US1000 Module

US1000 Module	
SK, AH / VLSI Solution Oy 2023	
TITLE: vs1kmod182	
Document Number:	REV: 1.81
Date: 11.5.2023 13.37	Sheet: 1/1

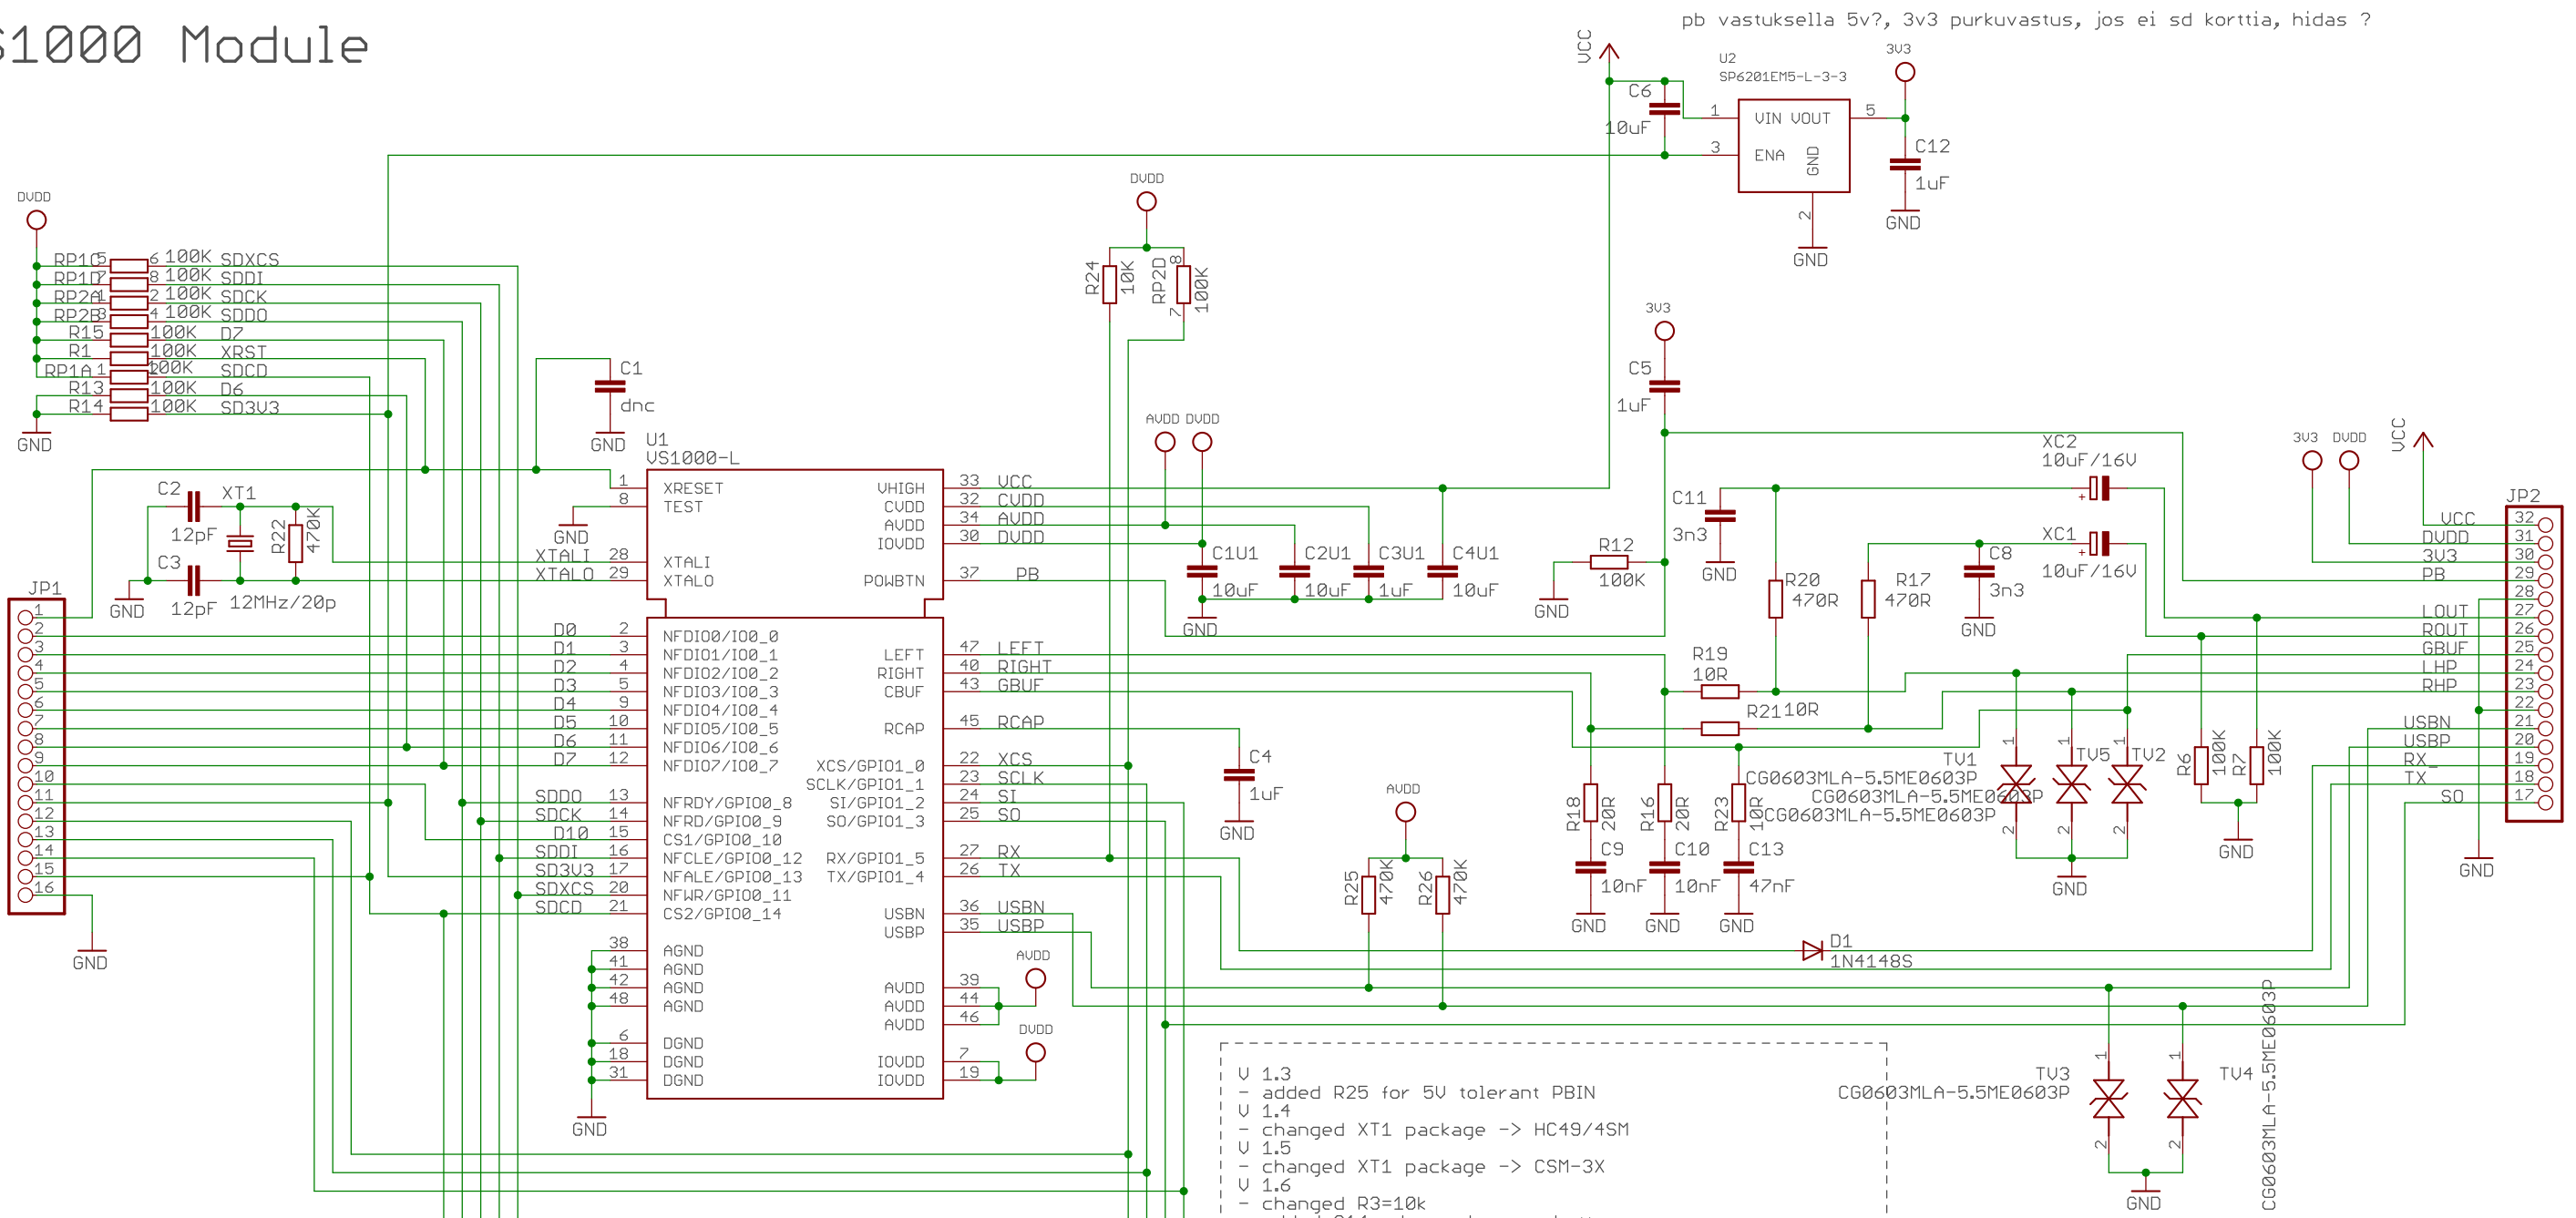
- U 1.3 - added R25 for 5V tolerant PBIN
- U 1.4 - changed XT1 package -> HC49/4SM
- U 1.5 - changed XT1 package -> CSM-3X
- U 1.6 - changed R3=10k
- added C14, changed power button signal source to 3V3.
- added D1
- U 1.61 - changed C14=10uF
- changed C5,C8=22pF
- U 1.62 - changed 2014->2016
- U 1.63 - converted to eagle7
- changed R1, C5 ja C1 packages to standard ones
- U 1.64 - changed all 0402 and 0604 packages to standard ones
- fixed DRC errors, silkscreen cleanup
- U 1.7 - 2021
- reset capacitor, routing improved
- crystal components optimized
- BOM manufacturing optimizations
- v.1.75 Manufacturing improvements:
 - elcap moved
 - origin moved to 0,0
 - sd card connector origin and position adjusted
 - name change:
 - ic->u
 - elcap->xc
 - sd conector->xn

- v.1.76 - elcap package edited
- libraries merged to "audio_modules.lbr"
- v.1.77 - components renumbered
- v.1.78 - 8 resistors changed to resistor arrays
- v.1.79 - C1 -> dnc
- PCB markings improved
- v.1.80 - diode pad increased
- v.181 - 0402 pads decreased in audio_modules.lbr -> 0402P
- v.182 - 0603 pads decreased in audio_modules.lbr -> 0603P, 0603BRN
